White Rock Solar Farm (WRSF) – SSD 16_7487 – Modification Application

This letter relates to an application for minor modification of Development Consent SSD 7487 approved on 14 June 2016. The consent applies to the 20 MW White Rock Solar Farm (**WRSF**) that is currently under construction. WRSF is located adjacent to White Rock Wind Farm (**WRWF**).

Attachment -A - White Rock Solar Farm – SSD 7487 MOD 1 – Temporary Parking Area

Attachment -B - White Rock Solar Farm – SSD 7487 MOD 1 – Variation to Cable Route

Figure 2 – Updated Figure showing Temporary Car parking area and revised Cable Route WRSF to WRWF

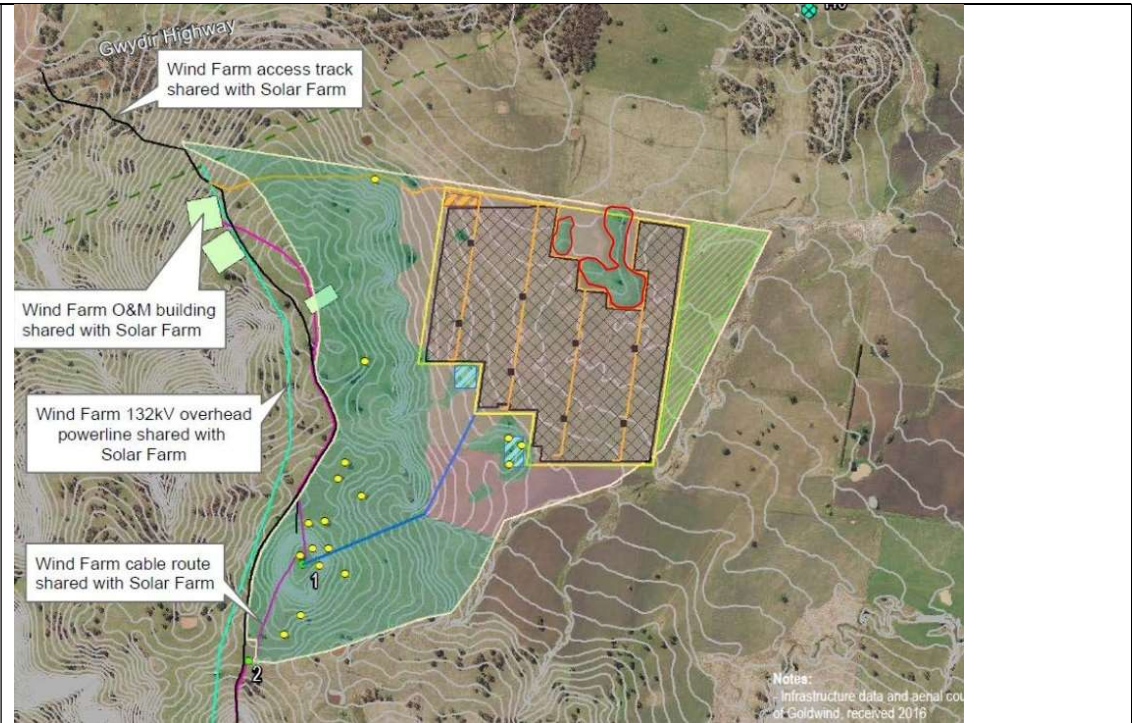
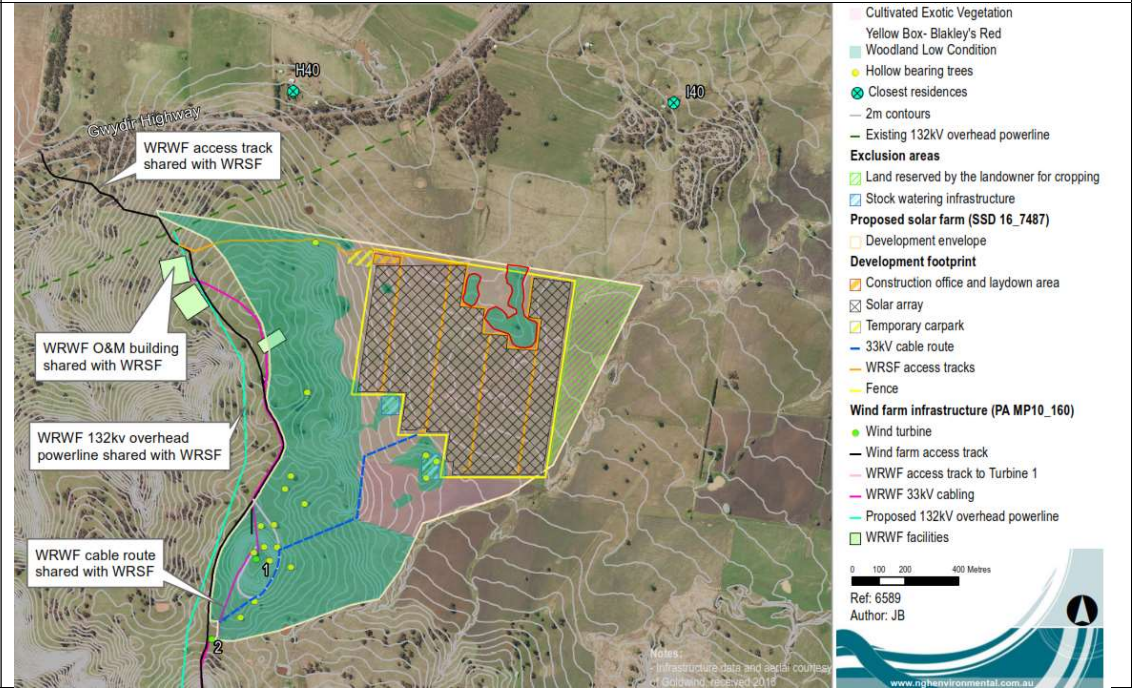
The proposed temporary car parking area is located (see attached Figure 2, following Attachment C) at the entry to the fenced solar farm area, adjacent the site access track and, in an area of exotic pasture. Subject to approval for the modification, it is proposed that the Final Design Layout Plan (required by Condition 5) be updated to show the location and extent of the temporary car parking area.

For site safety purposes, UGL proposes that the car park will have a gravel surface to provide a secure and safe area to drive on. A small area to the northwest of the proposed car parking area is mapped as EEC and the car parking would be fenced to prevent inadvertent vehicle access to the EEC area beyond the car park area. The car parking area would be rehabilitated upon completion of construction and returned to its former pastoral use.

The amended cable route proposed by UGL is similar to that in Appendix 1 of the Consent but is varied slightly in proximity to Turbine 1 and align with WRWF cable route south of Turbine 1 (Figure 2). The variation provides for more efficient and safer trenching and cable installation, avoids cross over with existing WRWF 33kV cabling, reduces erosion risks by staying on lower slope land, would be partly co-located within the disturbance footprint of the WRWF access track (no additional vegetation impact), is within areas assessed for flora and fauna and heritage potential (either for WRWF or WRSF) and, stays within the vegetation clearance limit (0.21ha) prescribed in Schedule 3, Condition 7b of the Consent for this element.

Further, the landowner has requested that the portion of cable between the solar farm and the EEC be relocated slightly to the west within the exotic pasture along the edge of the EEC boundary to minimise conflicts between the cable and ongoing agricultural use of the paddock (i.e. to maintain the ability for cultivation of the paddock).

The implementation and use of the proposed additional car parking area would require revision to Appendix 1 of the Development Consent, see temporary car parking in the attached Figure 2 and, subject to that change, the temporary facility would be consistent with the existing Conditions of Consent. No change to conditions is sought for this aspect.

Subject to approval for the minor variation to the cable route and, in conjunction with minor variation for car parking, *Appendix 1 – General Layout* of the Consent would need to be updated to show the minor variations. There is no change required to any of the Conditions of Consent for this minor variation however, the Final Design Layout Plan required by Condition 5 would need to be resubmitted.

WHITE ROCK SOLAR FARM
ELECTRICAL
SITE LAYOUT
PROPOSED CAR PARK & ALTERNATE CABLE ROUTE
PLAN

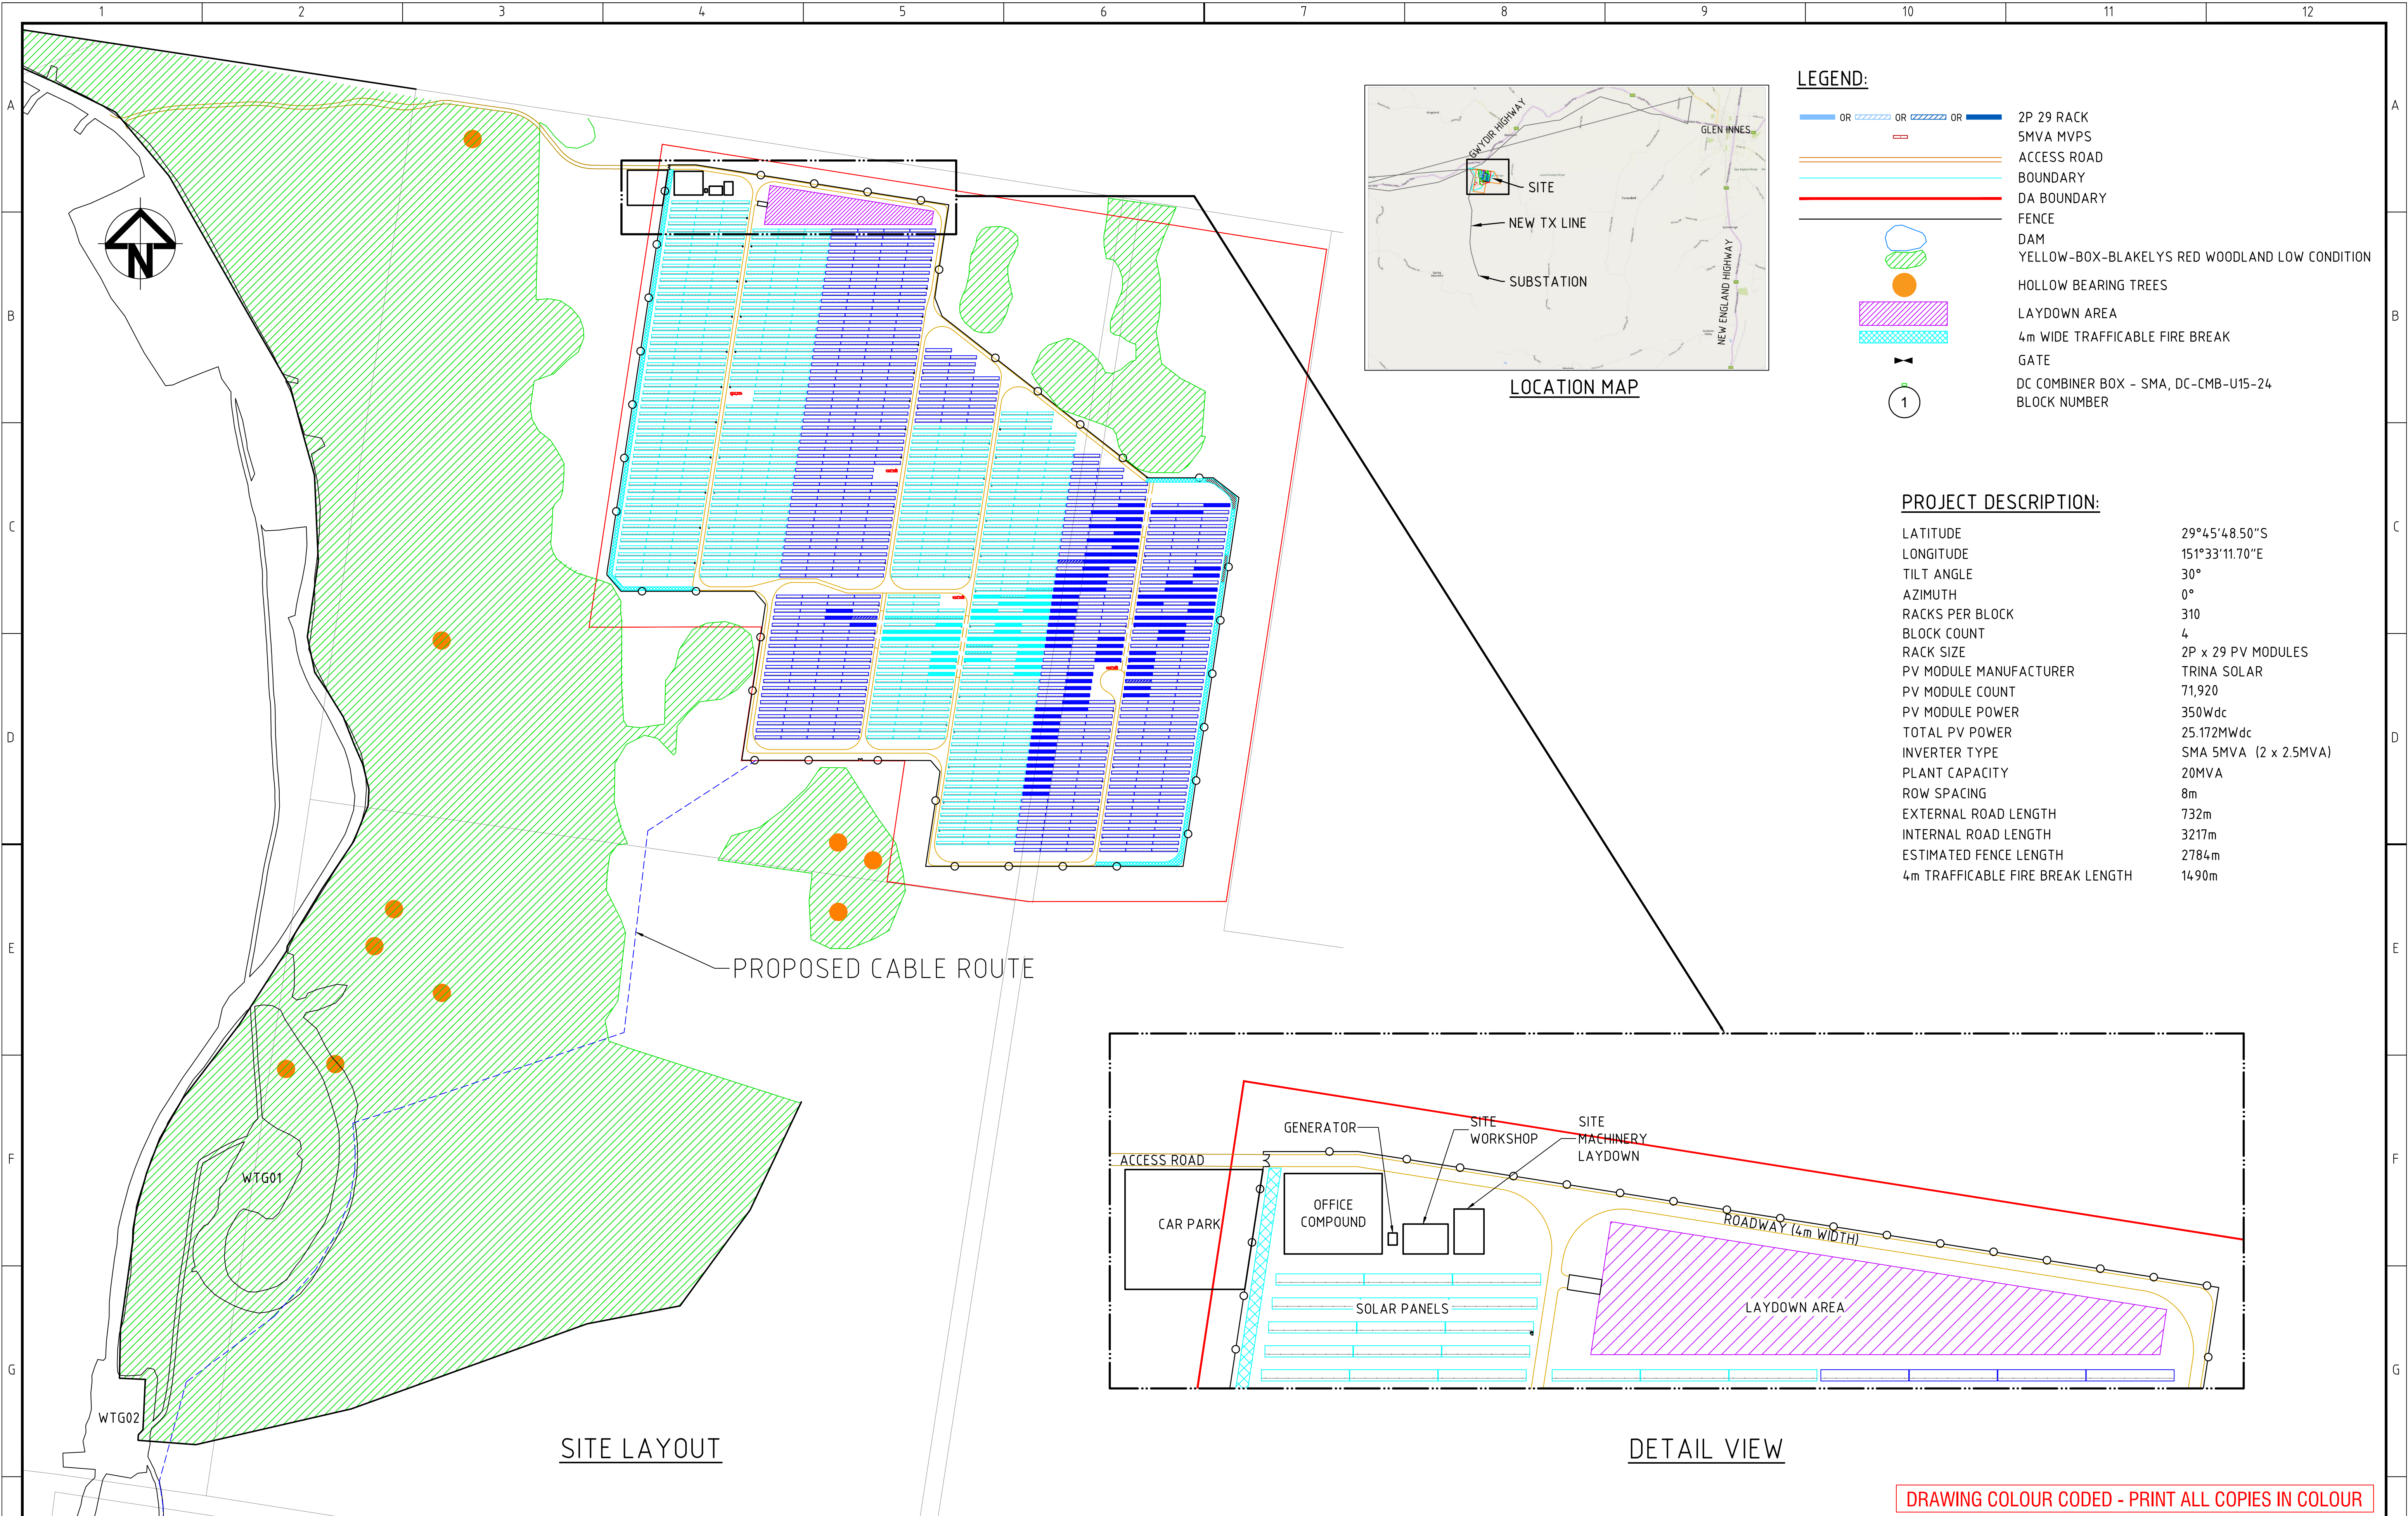
- Minor variation to site layout to include a temporary car parking area as shown on the attached plan (**Attachment A, Attachment B - Figure 2 and Attachment C**); and
- Minor variation to the route of the 33kV cable from the White Rock Solar Farm to the vicinity of Turbine No. 1 (**Attachment B and Attachment B - Figure 2 and Attachment C**).
